工程指示 / 要求簡箋(E.I.)

工程指示編號：EI / 9685 / 18

工程名稱：觀塘裕民坊

工程項目：幕牆 鋁料模具生產(暫停 2 個模)

CUSTOMER	HONGKONG CO.	CUSTOMER APPROVAL	CUST PART NO.	X85558
			SECTION NO.	LH0089924

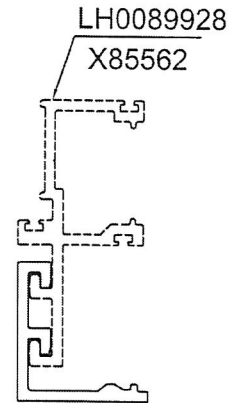
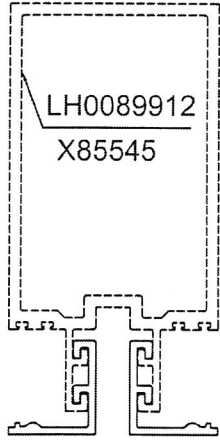
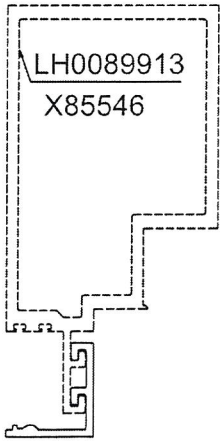
A 版暫停 2 個模

(X85558, X85593)

1. 玻璃線勾要改厚度，使勾不會因膠條厚度而移動

扣蓋膠

(兩項修改將會發出新紅改技圖)

CUSTOMER	HONGKONG CO.	CUSTOMER APPROVAL	CUST PART NO.	X85593
			SECTION NO.	LH0089939

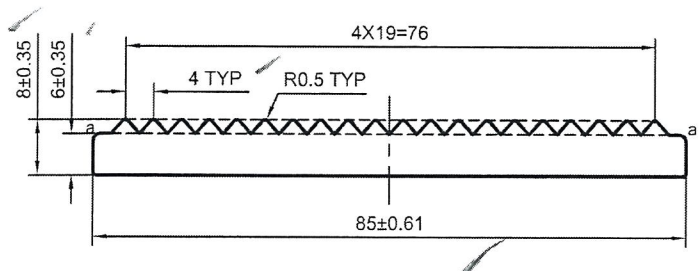
2. 鋁介子牙尺寸有修改
